Planning and Land Use Committee Report

Subject: Development Permit Application No. 000398 for 1146 Caledonia Avenue

RE: 1146 Caledonia Avenue revised proposal for Official Community Plan Amendment, Rezoning and Development Permit Application.

Landscape Plan

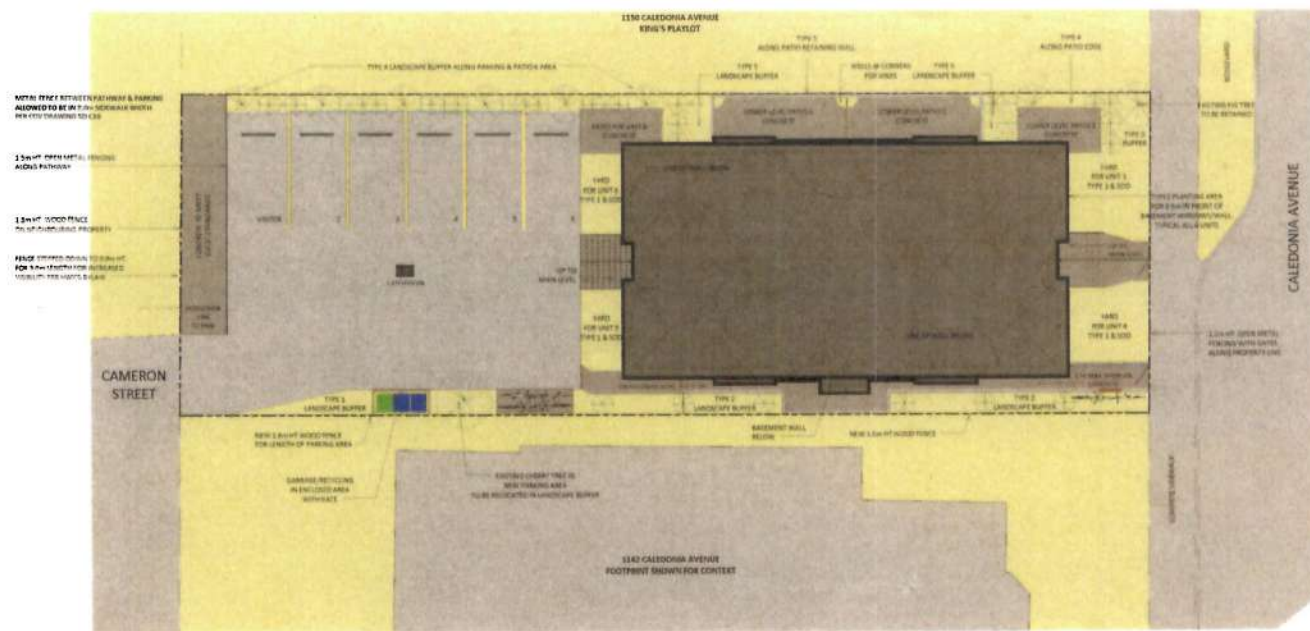
4. Please provide a separate Landscape Plan with labels for trees, plantings and hard materials.

Drawing has been provided on A0.01.
